ADDENDUM NO. CC-2

NORTHEAST COMMUNITY COLLEGE WELLER BUILDING BASEMENT REMODEL
801 East Benjamin Avenue
Norfolk, NE 68702-0469
BCDM Project No. 3507-01

addendum

project name: Northeast CC – Weller Building Basement Remodel

1 LOWER LEVEL - PLUMBING & MECHANICAL PIPING
1/8" = 1'-0"

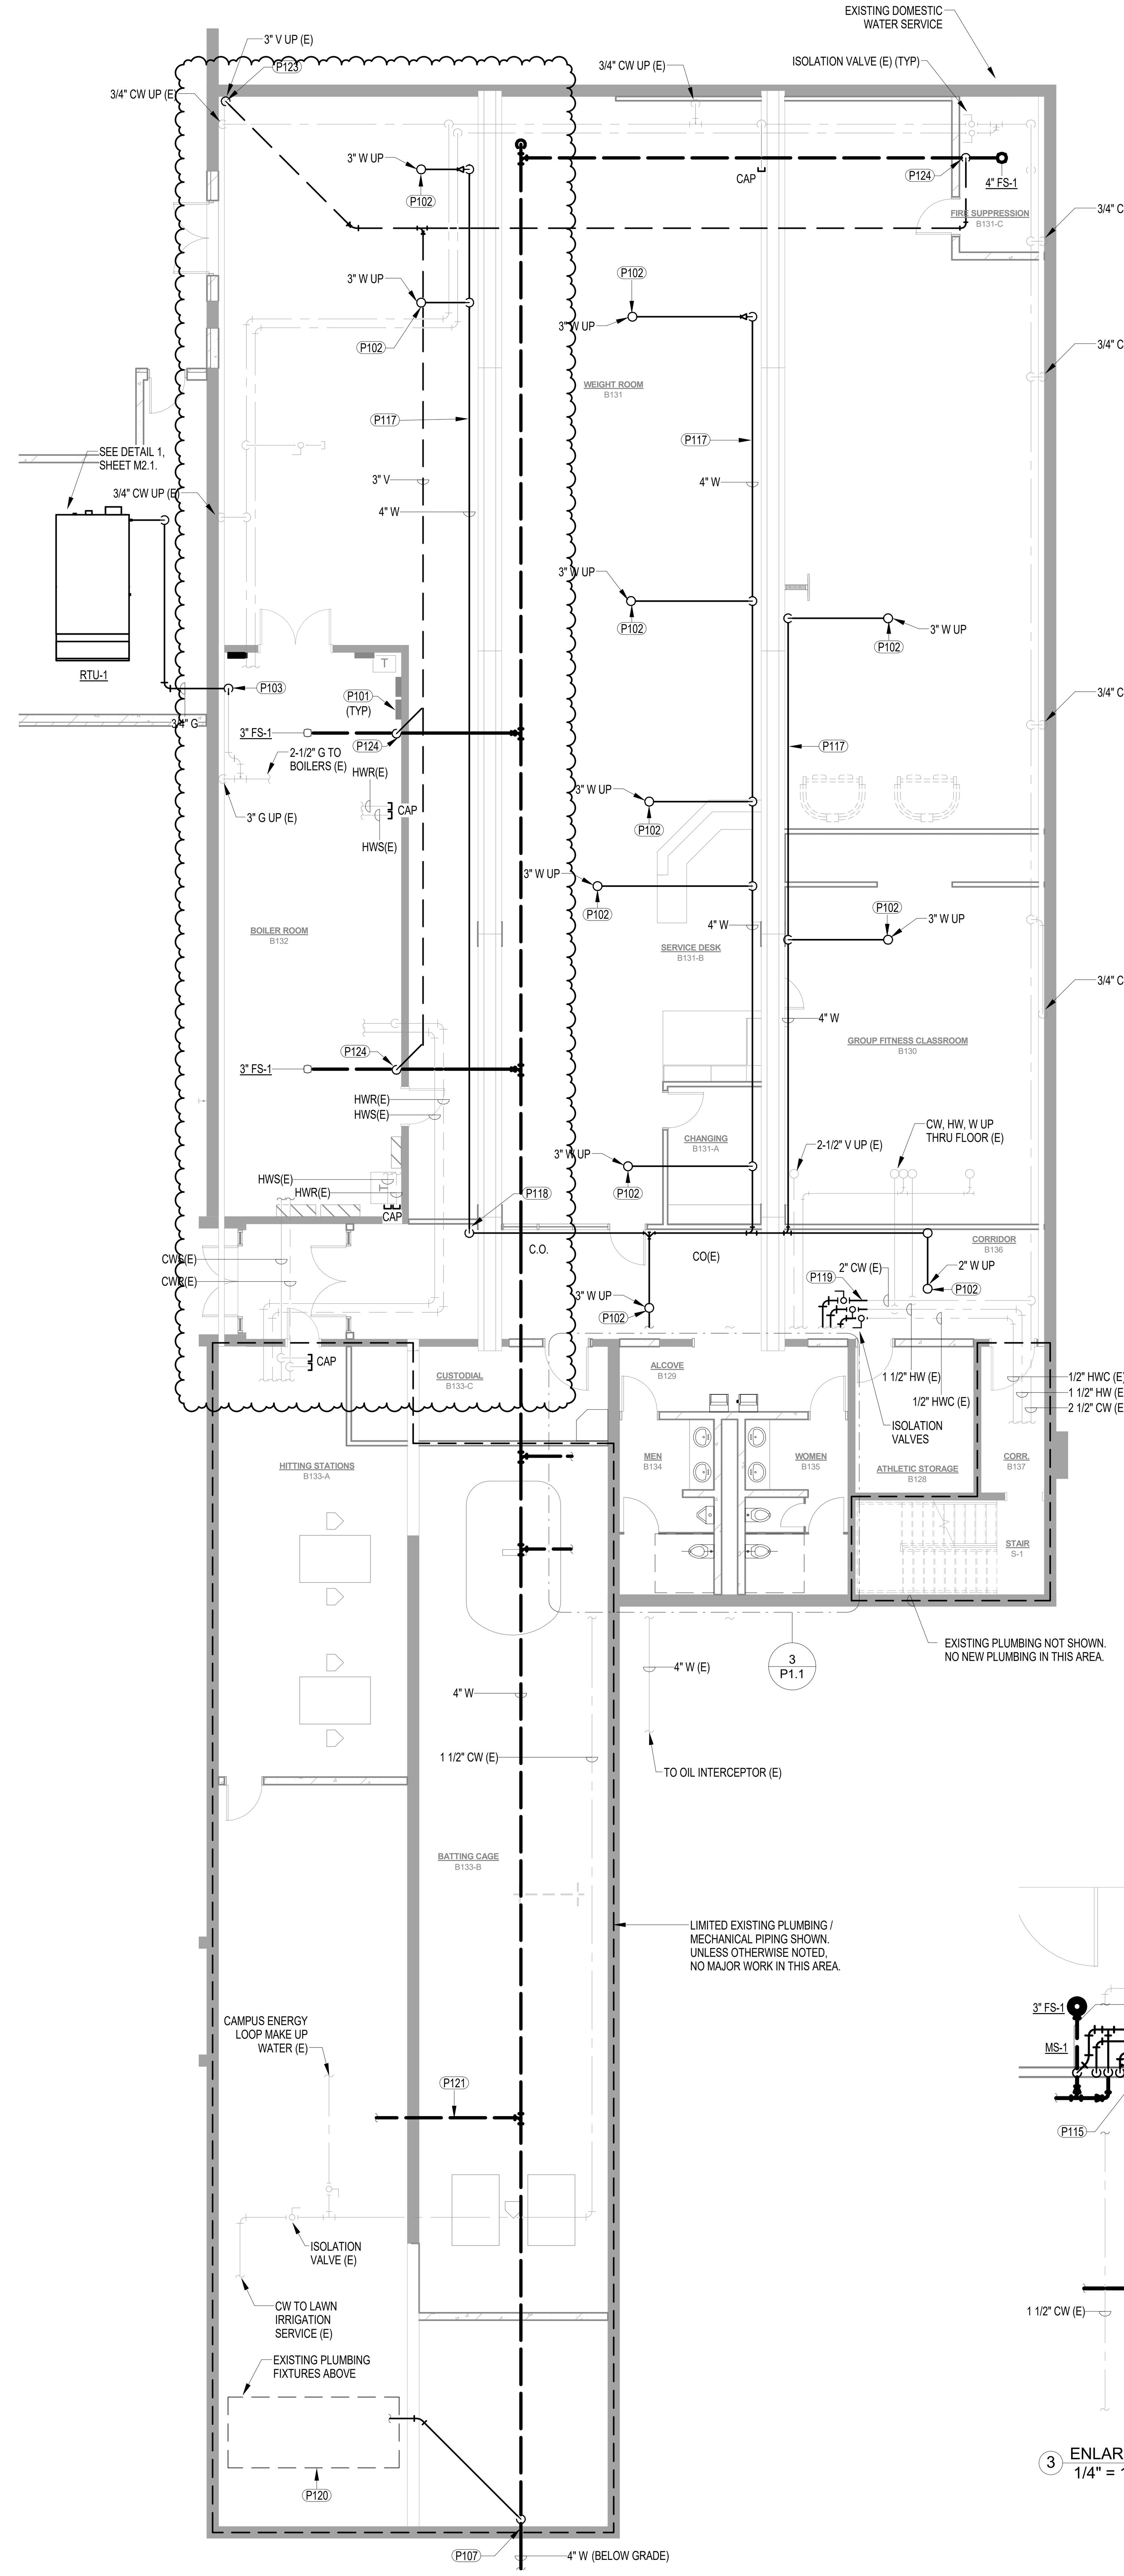
4. Sheet P1.1 – Plan 1
    a. Boiler Room B132: Provide two new floor sinks and associated waste & vent piping.
    b. Boiler Room B132: Revise main vent piping to accommodate new floor sinks.

P2.2

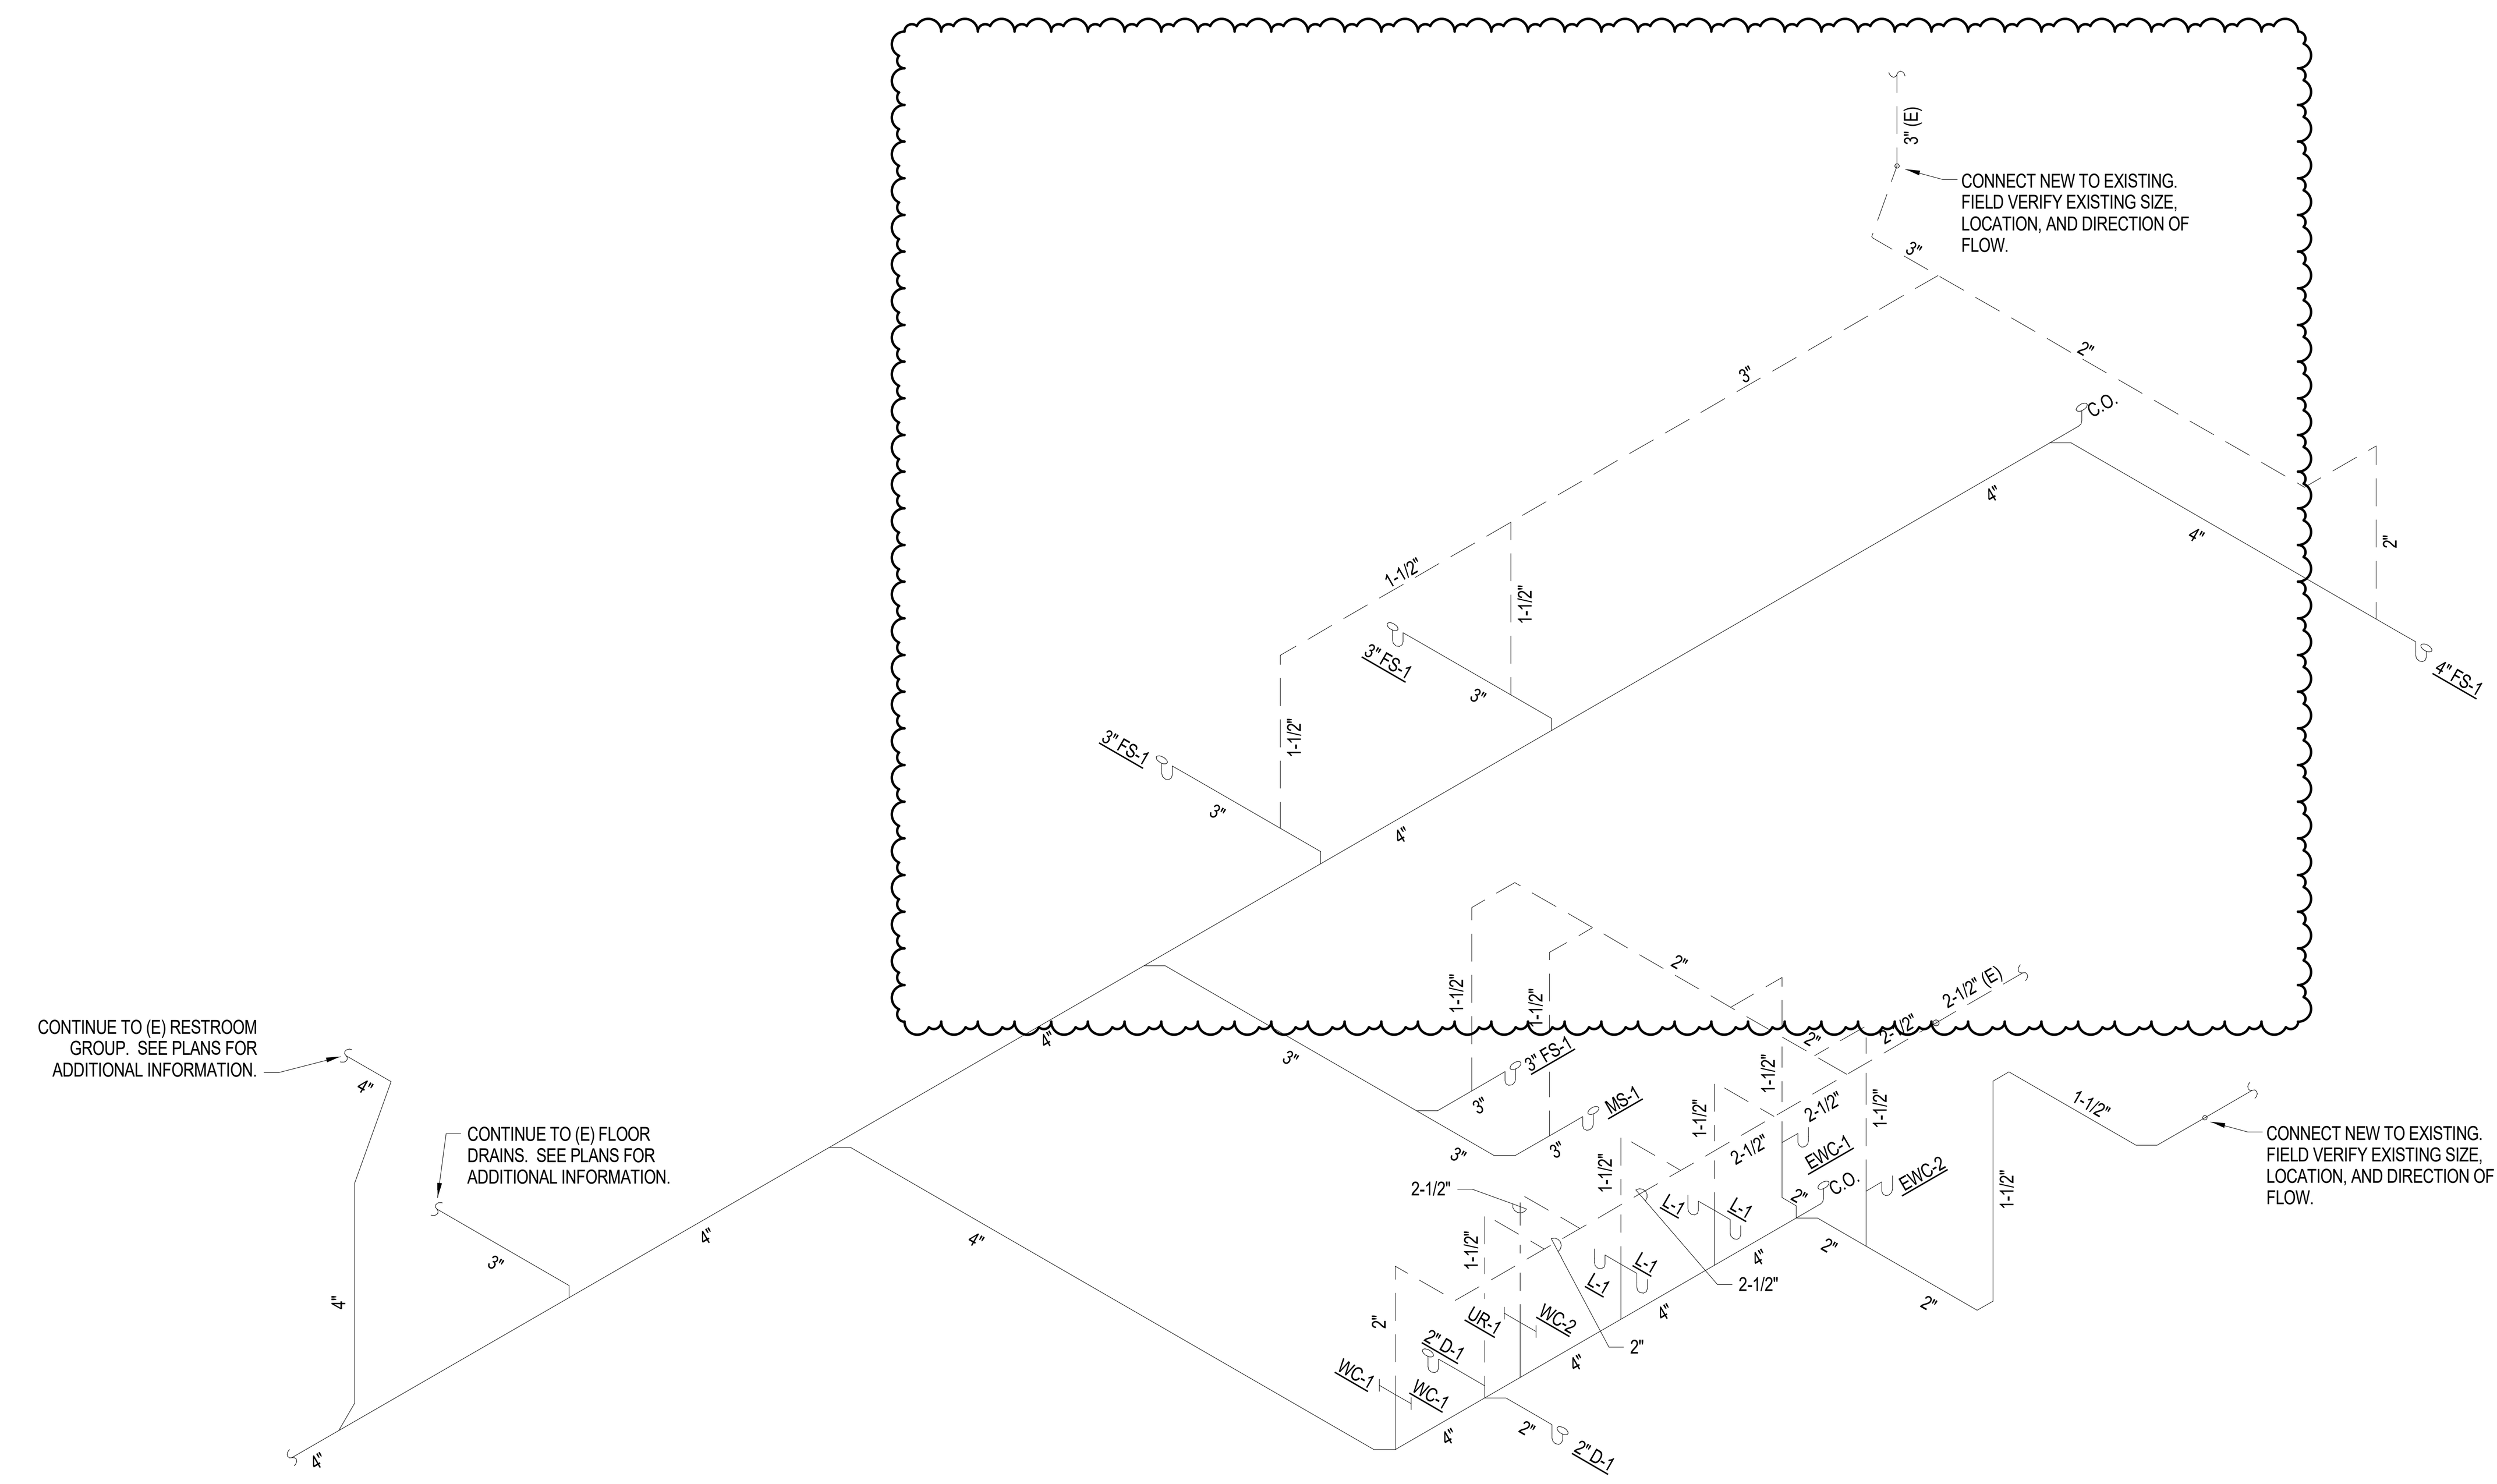
6. Sheet P2.2 – Waste & Vent Riser Diagram
    a. Revise to reflect replacement of Boiler Room floor sinks.

3 LOWER LEVEL - POWER
1/8" = 1'-0"

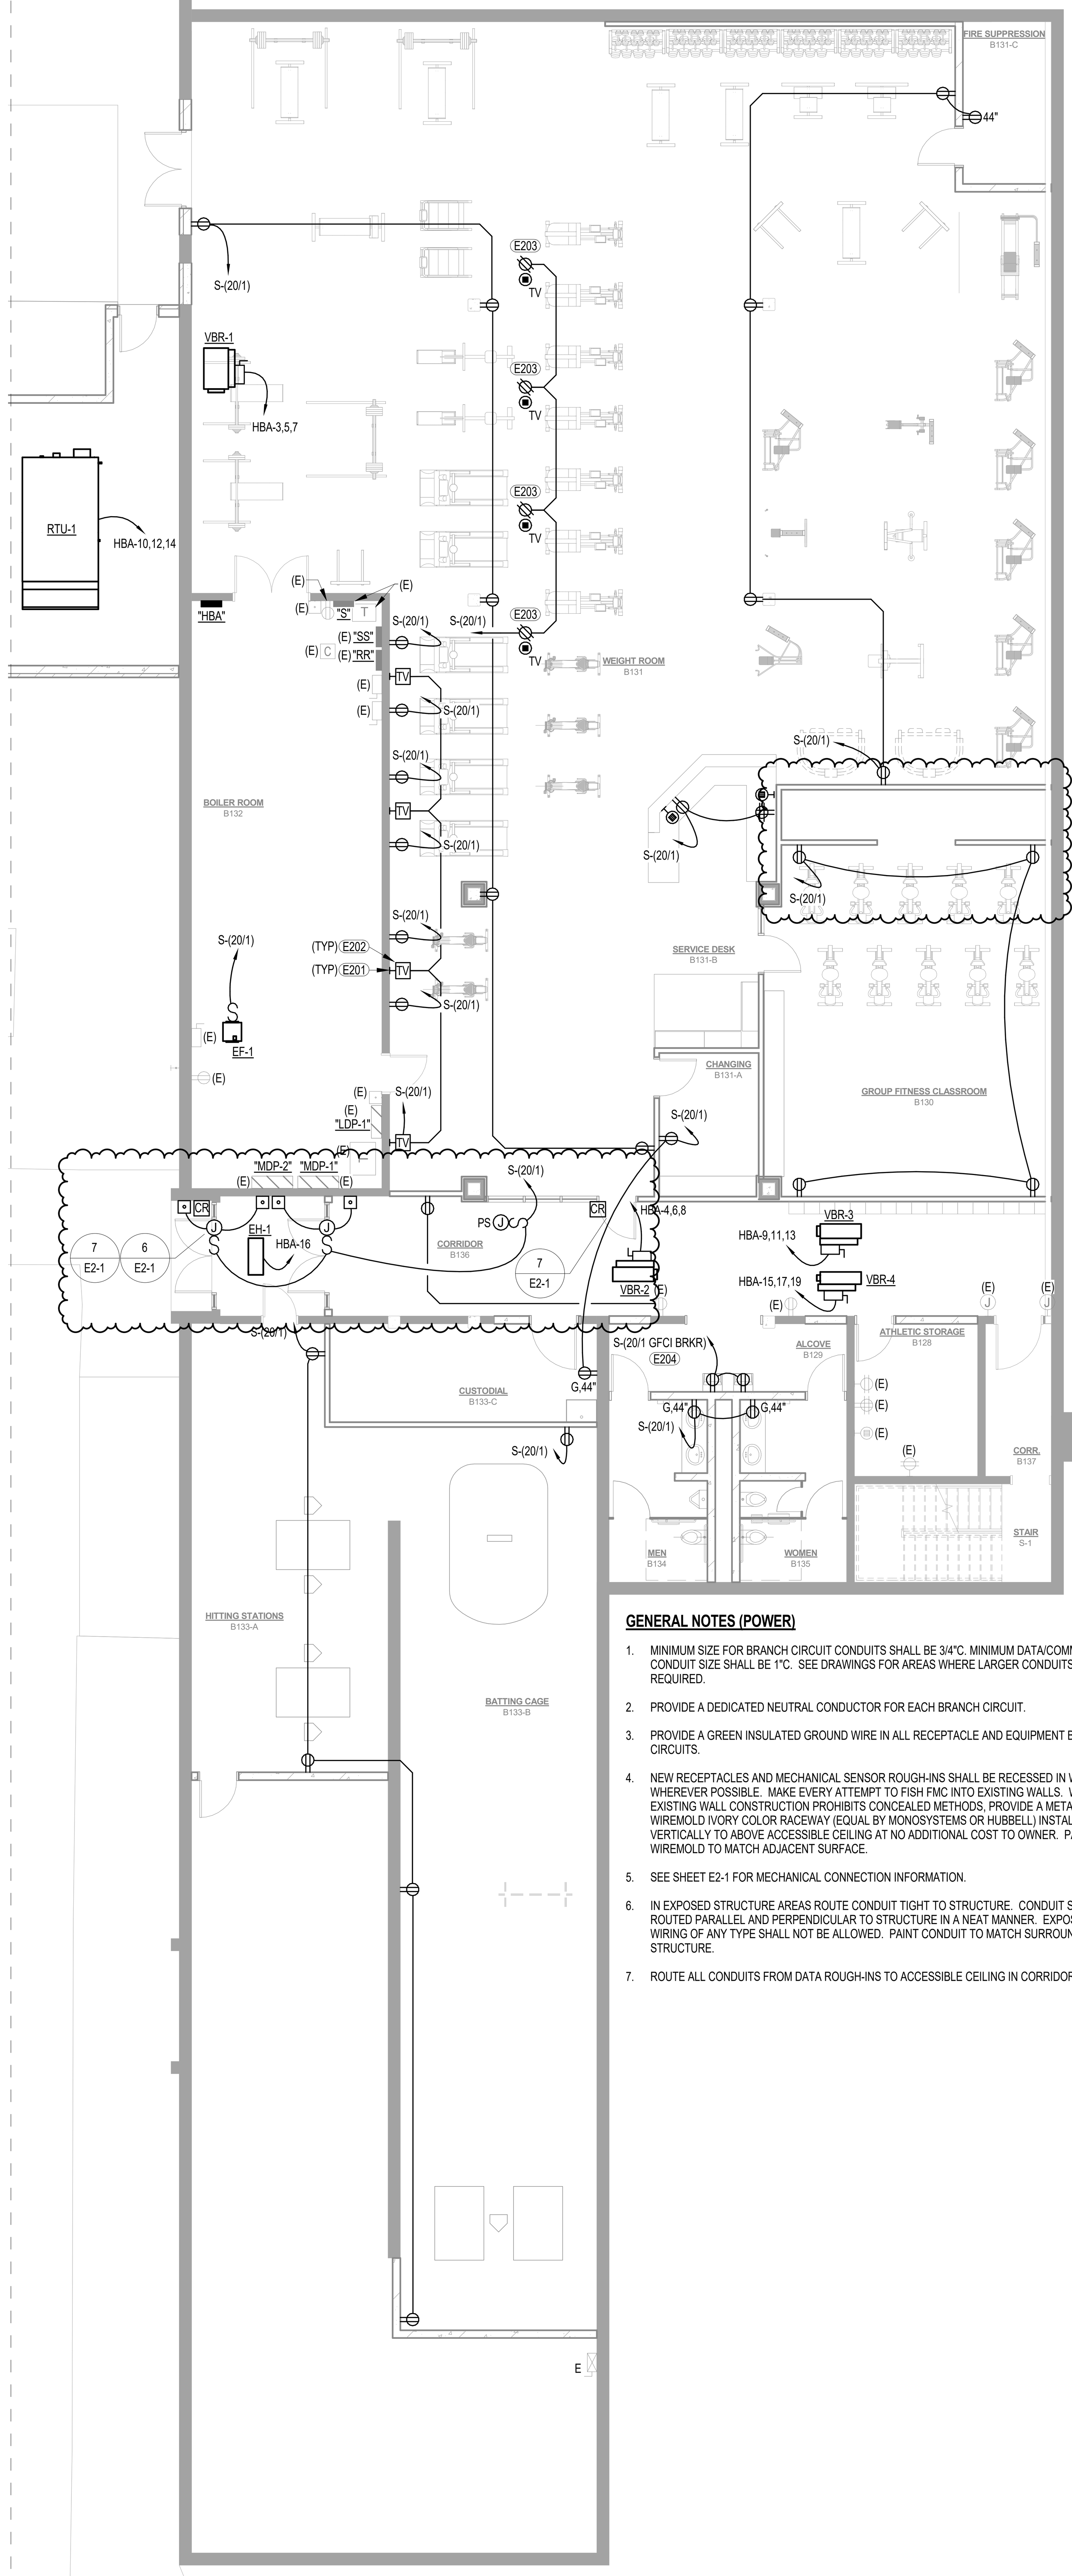
b. Modify lighting layout in Men B134 and Women B135. See 2/E1.1.
c. Modify lighting control in Group Fitness Classroom B130 and provide lighting control for small storage within room. See 2/E1.1.
d. Provide card reader rough-ins and door rough-ins in Corridor B136. See 3/E1.1.
